Village of Arlington Heights
Plan Commission
Board Room
Arlington Heights Village Hall
33 S. Arlington Heights Road
Arlington Heights, IL 60005
October 24, 2018
7:30 PM

File Number: PC 18-018
Project Title: Taco Bell Redevelopment
Address: 1530 W. Algonquin Rd.
PIN: 08-08-401-064

File Number: PC 18-019
Project Title: Napleton Repair Facility
Address: 3650 N. Wilke Rd.
PIN: 02-01-401-021

FLOOR PLAN 1/4"=1'-0"

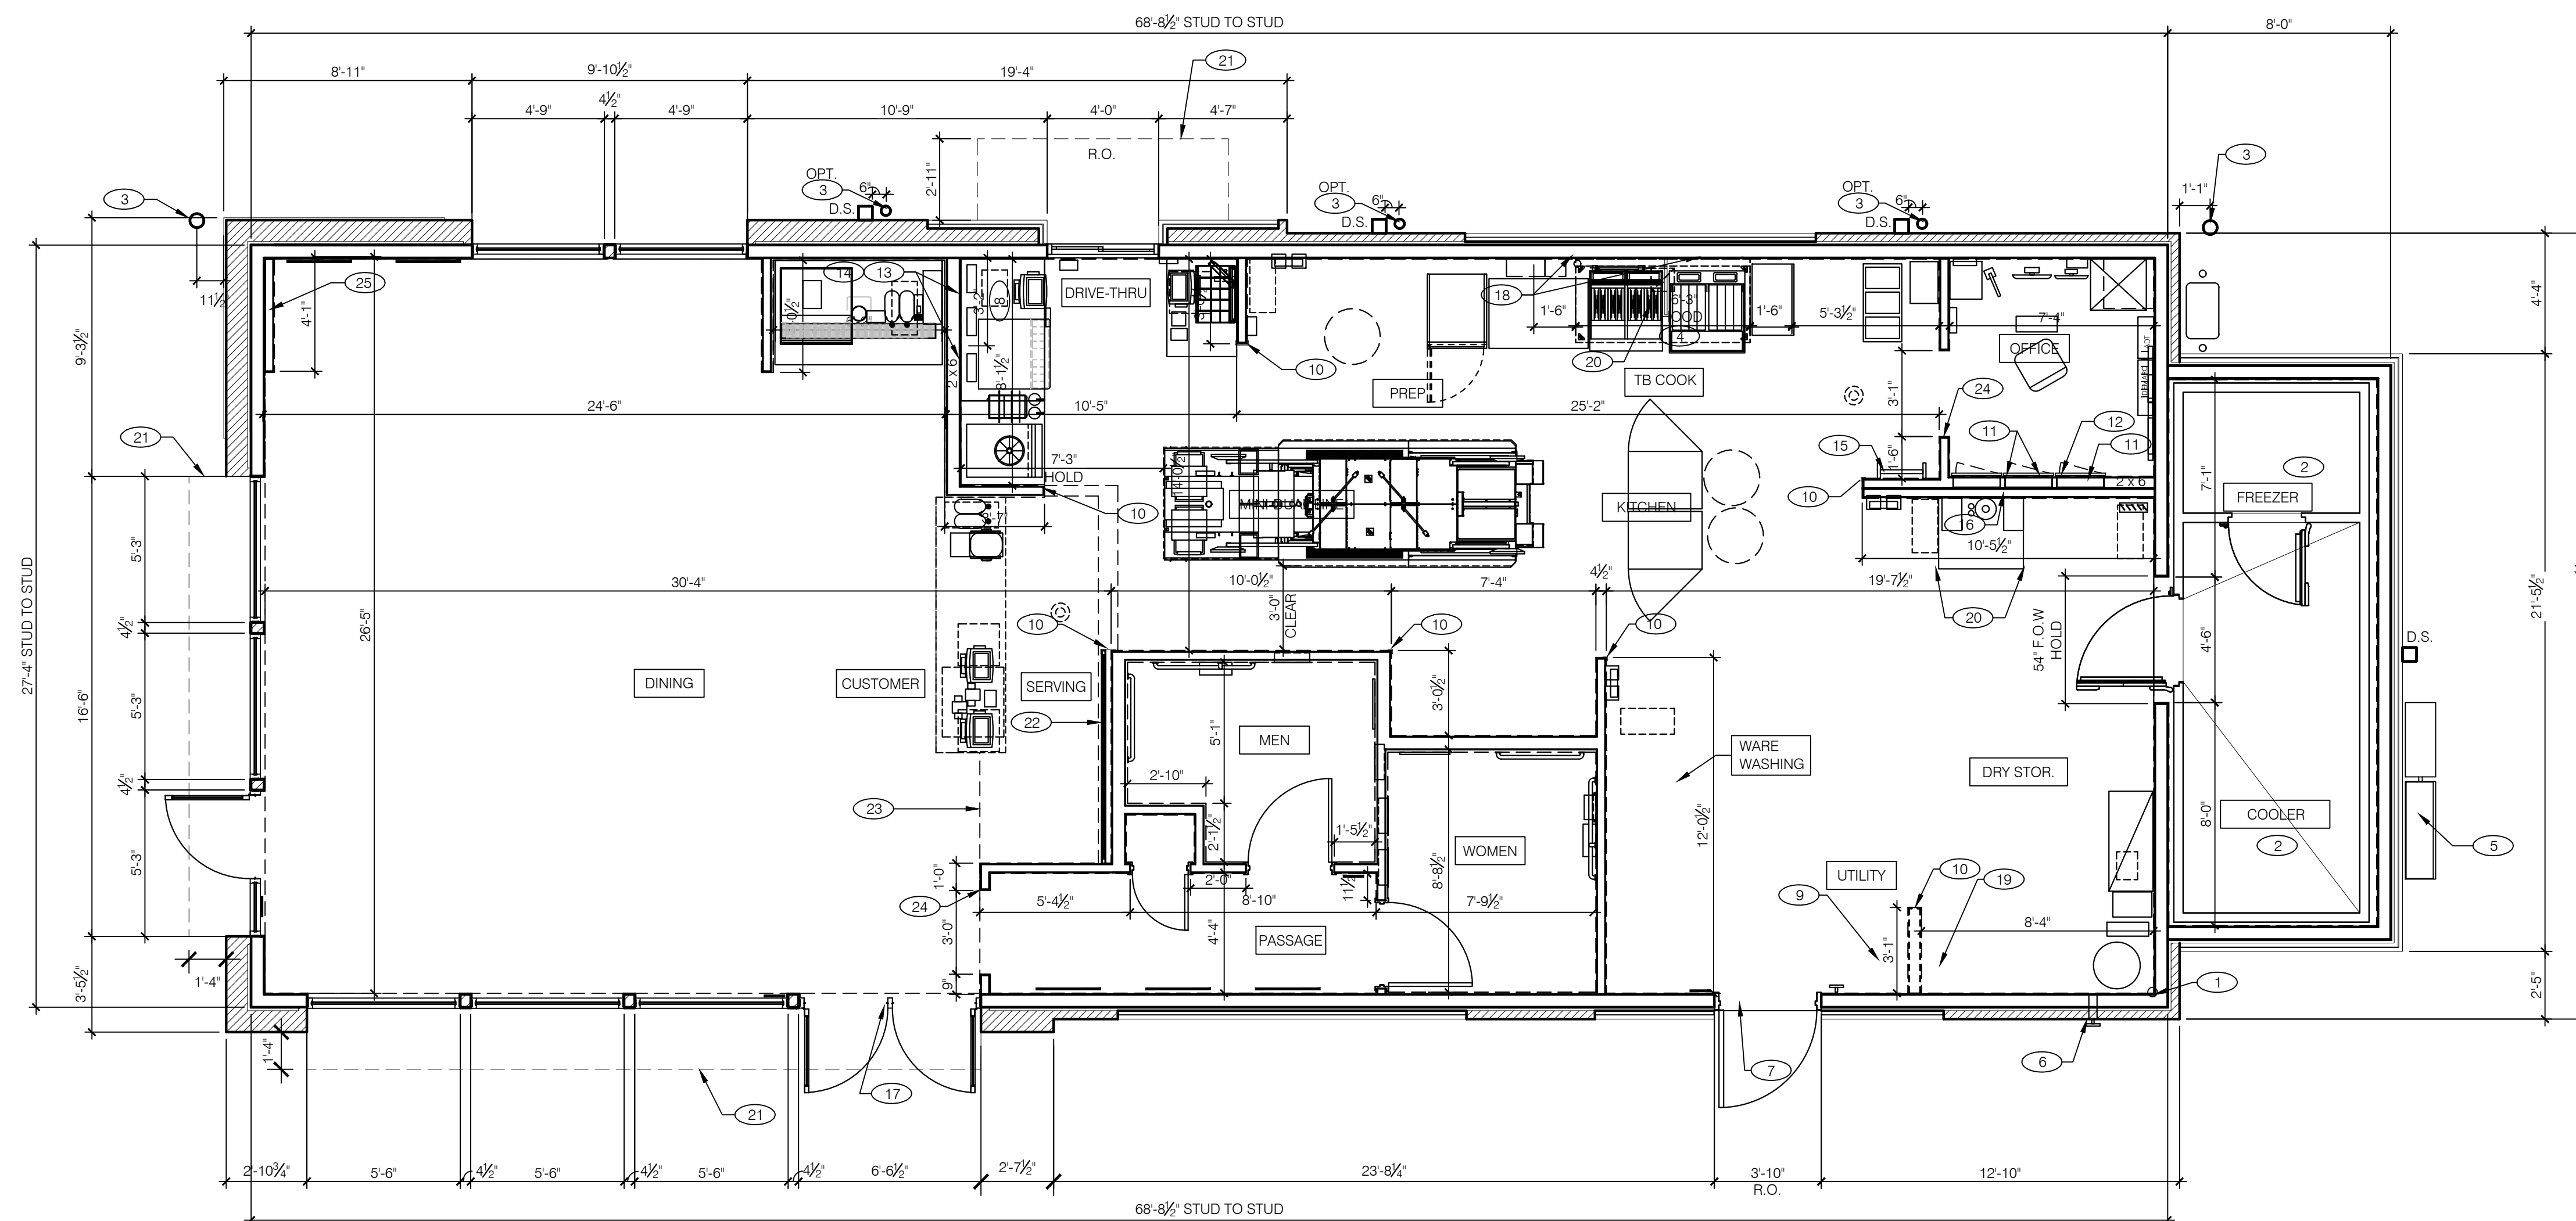
21. Please add to sheet A1.0 a dashed line around the seating area within the restaurant and provide the total square footage for this area.

Response: See added Key Note 23 on sheet A1.0 for outline of the seating area and area calculation.

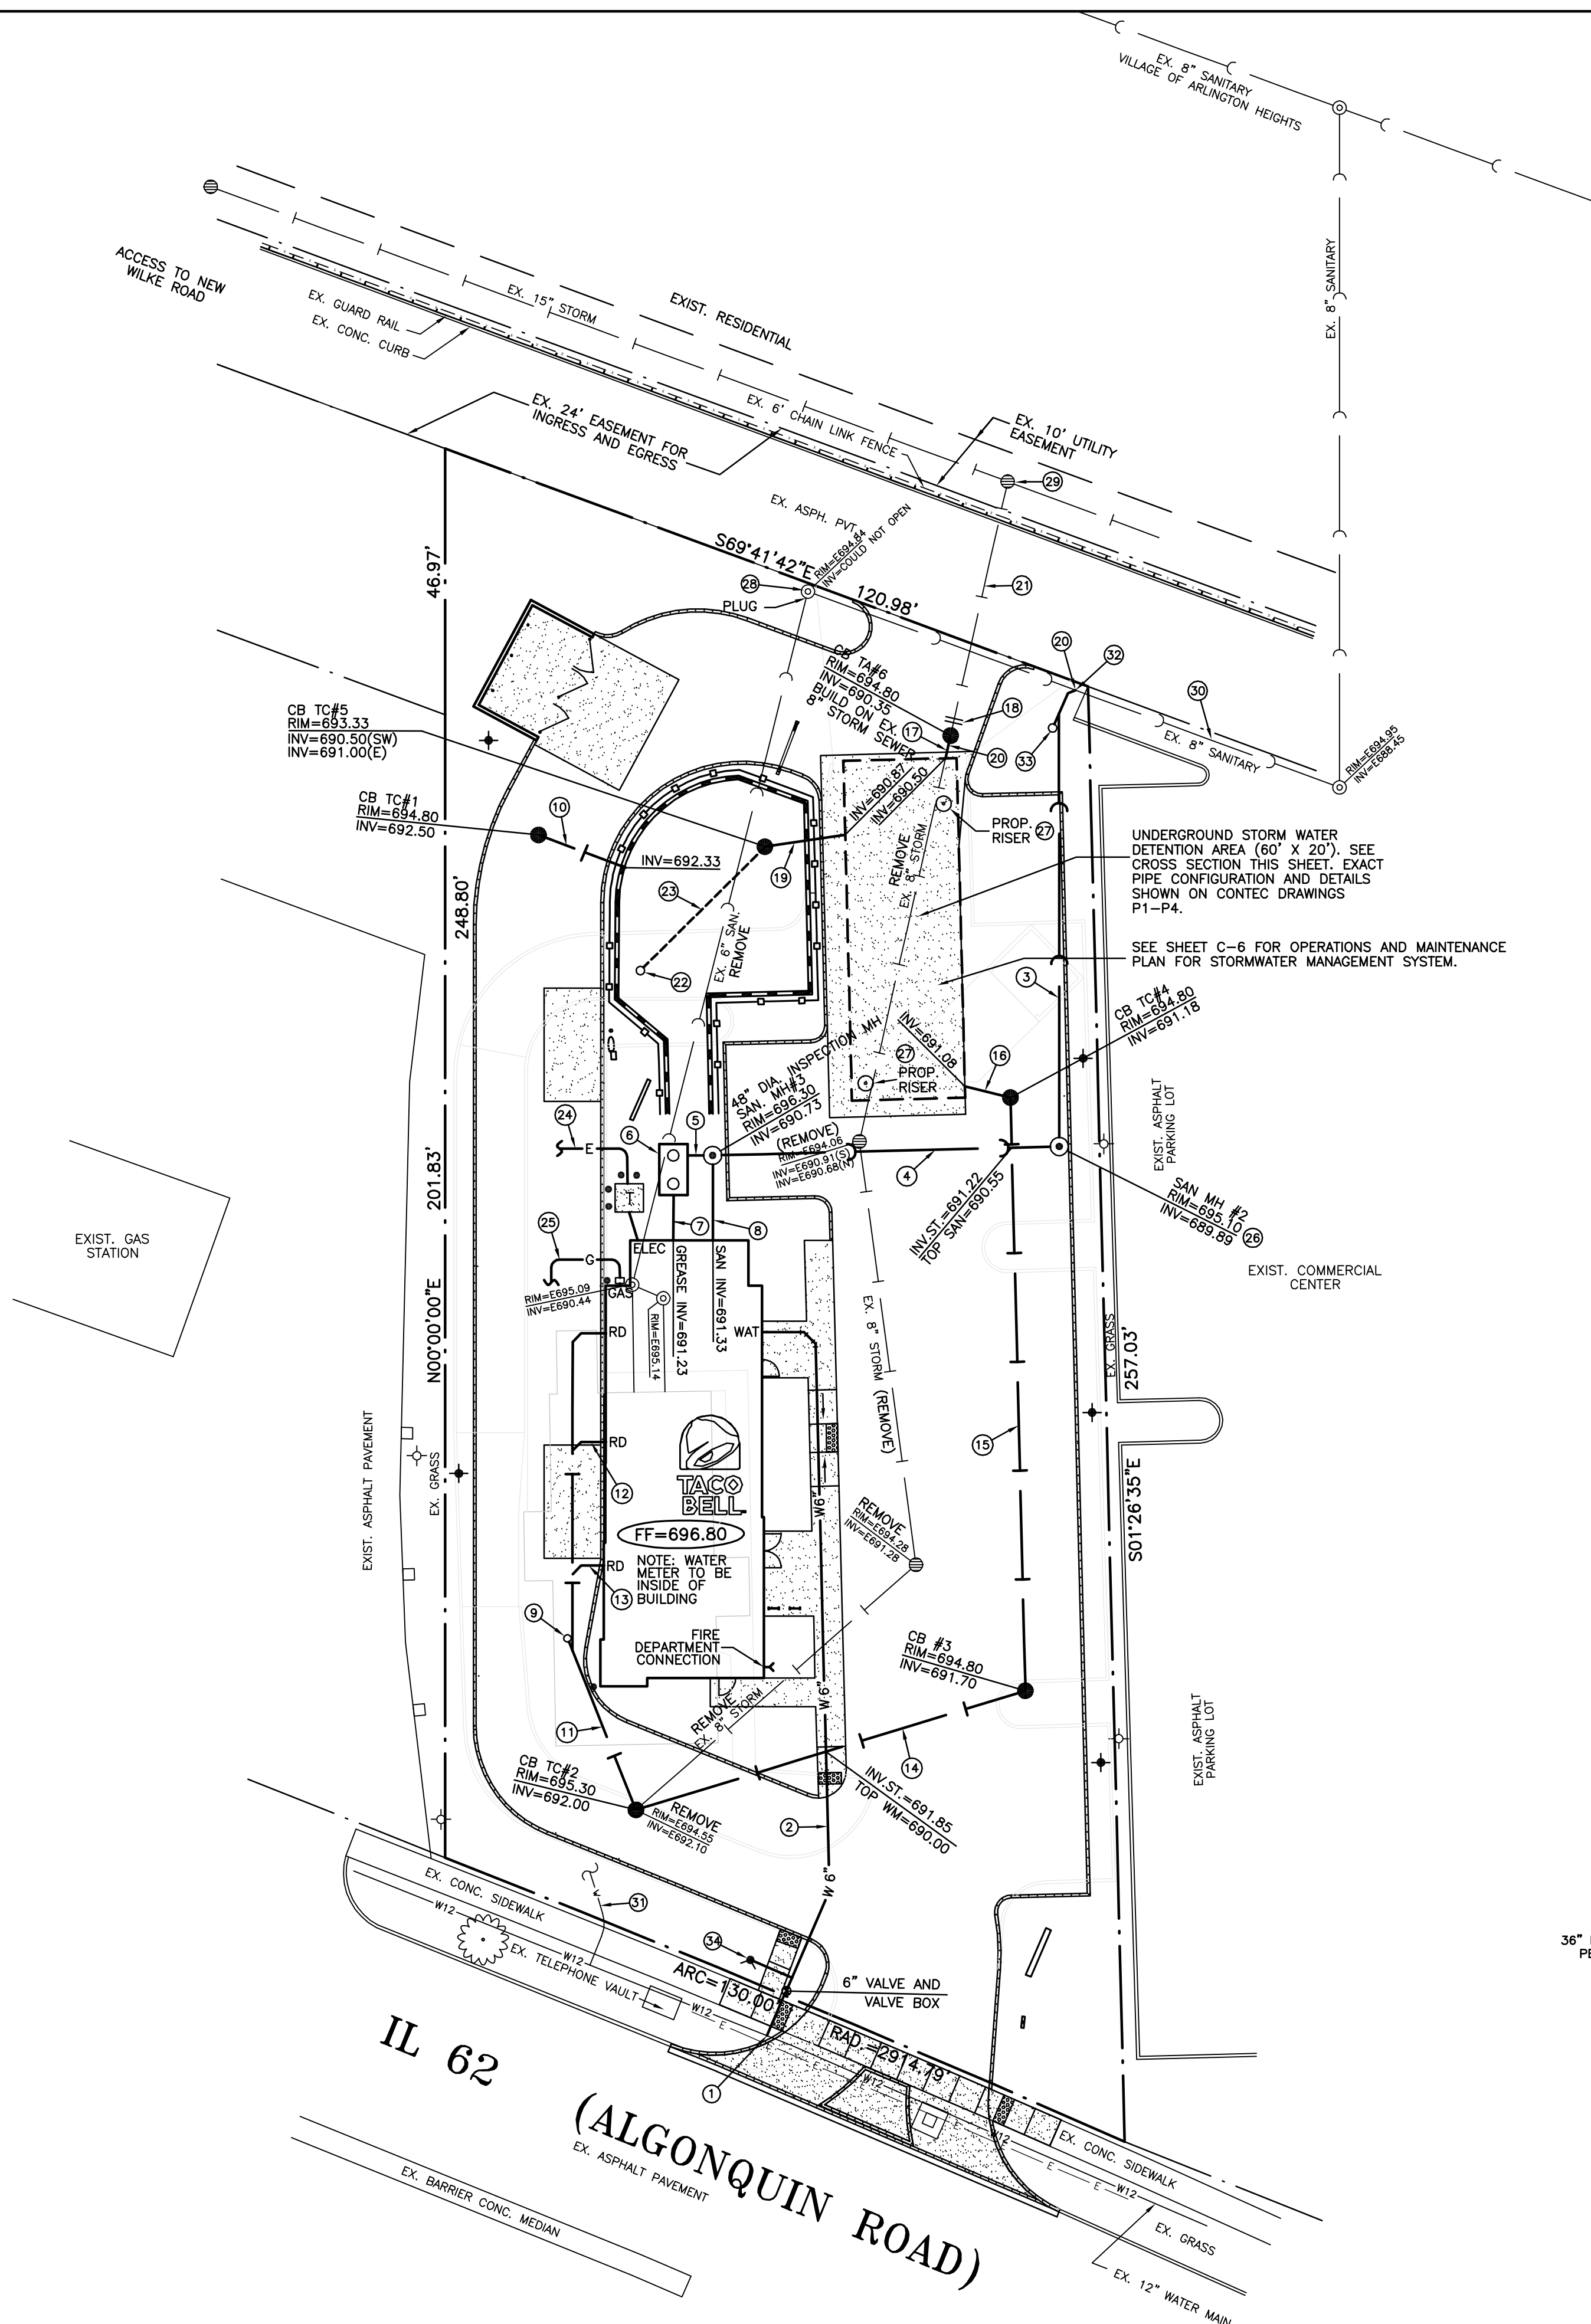
28 CONTRACTOR SHALL INSPECT EXISTING SANITARY MANHOLE IN THE PRESENCE OF THE VILLAGE AND MWPD INSPECTORS, AND MAKE ANY REPAIRS TO THE MANHOLE AS REQUIRED TO BRING THE MANHOLE INTO GOOD AND OPERATING CONDITION.

29 CONTRACTOR SHALL INSPECT EXISTING CATCH BASIN IN THE PRESENCE OF THE VILLAGE AND MWPD INSPECTORS, AND MAKE ANY REPAIRS TO THE CATCH BASIN AS REQUIRED TO BRING THE CATCH BASIN INTO GOOD AND OPERATING CONDITION.

Response: A note has been added to sheet C-4 near the likely location of the existing water service that the existing water service shall be abandoned at the main.

Response: Notes 28 and 29 have been added to sheet C-4 to verify condition of existing manhole and catch basin, and repair if necessary.

Response: The sanitary sewer service line connection to the existing sanitary sewer at the northeast corner of site has been revised on sheet C-4 to be a blind connection.

Response: The Fire Department Connection will be located at the Southeast corner of the building above the landscaped area and south of the proposed bike racks. See sheet C-4 for specific locations of the connection and new fire hydrant.

PLATE RESTRICTOR DETAIL: SECTION

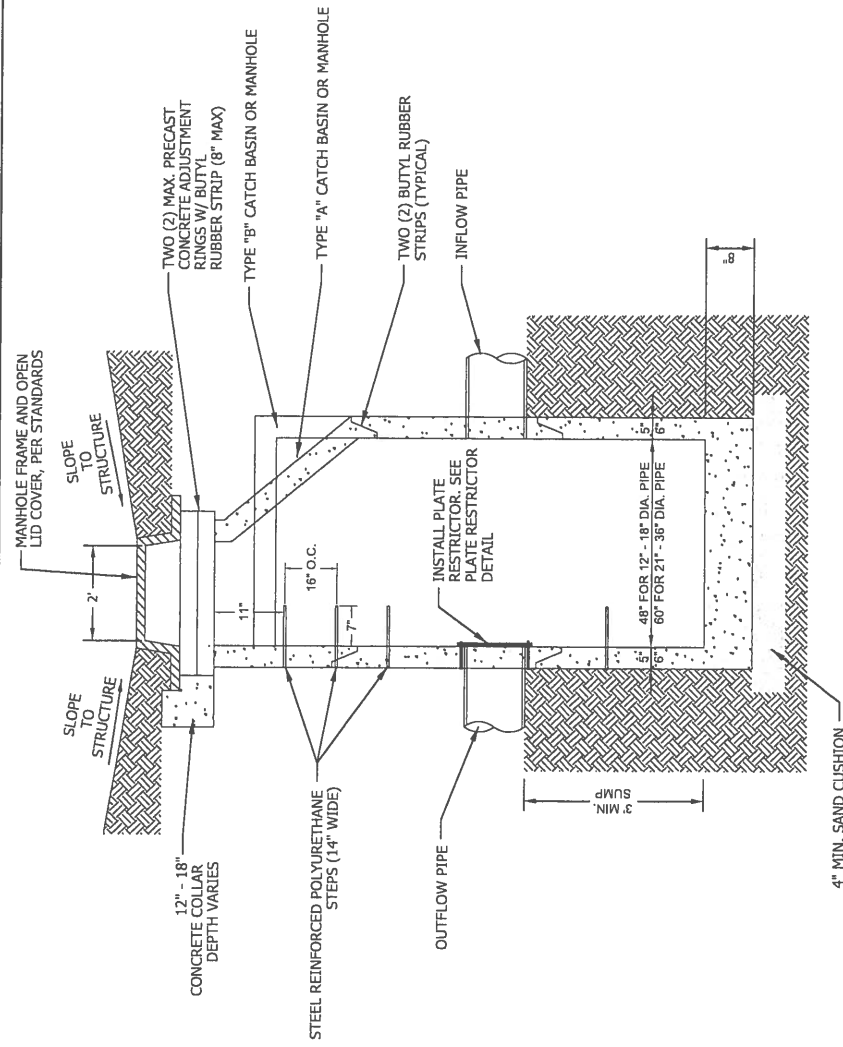
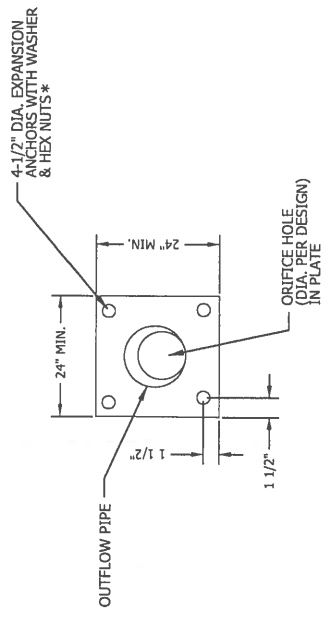
14. The petitioner's response to comment #4 is noted. Regarding the restrictor detail shown on sheet C-6, the restrictor should be installed vertically and a hood should be constructed over the outlet pipe. For reference, enclosed are a plate restrictor detail and hood detail from the Metropolitan Water Reclamation District. The revisions to the restrictor and the detention calculation verification for the fee in lieu of detention can be addressed at final engineering for the permit.

Response: The 2" restrictor for the project has been revised so that it is now a 2" hole cut in a plate with a trap. The detail is shown on sheet C-6. We did not use the Outlet Control Structure detail included with the review letter, because that detail did not fit the conditions under which storm water detention is being provided for the Taco Bell site. This was verified in a phone conversation we had with Mr. Mike Pagones, Village Interim Director of Engineering. If during the preparation of the final engineering drawings and calculations it is determined that the volume provided is less than the required 8,695 cubic feet, the developer will elect to pay the balance between the required volume and the provided volume as a fee in-lieu-of detention at the rate of \$1.00 per cubic foot, as suggested in the Village review letter.
